Well Name: JICARILLA APACHE	Well Location: T23N / R4W / SEC 8 / NENE /	County or Parish/State: RIO ARRIBA / NM
Well Number: 8	Type of Well: CONVENTIONAL GAS WELL	Allottee or Tribe Name: JICARILLA APACHE
Lease Number: JIC362	Unit or CA Name:	Unit or CA Number:
US Well Number: 3003908113	Well Status: Producing Gas Well	Operator: DJR OPERATING LLC

Notice of Intent

Plug and Abandonment Procedure
for
DJR Operating, LLC
Jicarilla Apache 8
API # 30-039-08113
NE/NE, Unit A, Sec. 8, T23N, R4W
Rio Arriba County, NM

CONDITIONS OF APPROVAL

Proposed Wellbore Diagram
DJR Operating, LLC
Jicarilla Apache 8
API # 30-039-08113
NE/NE, Unit A, Sec 8, T23N, R4W
Rio Arriba County, NM

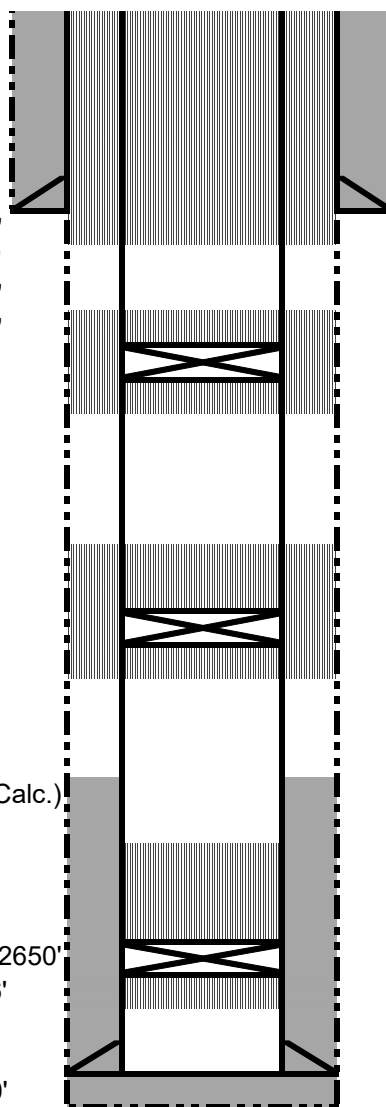
You are also required to place cement excesses per 4.2 and 4.4 of the attached General Requirements.
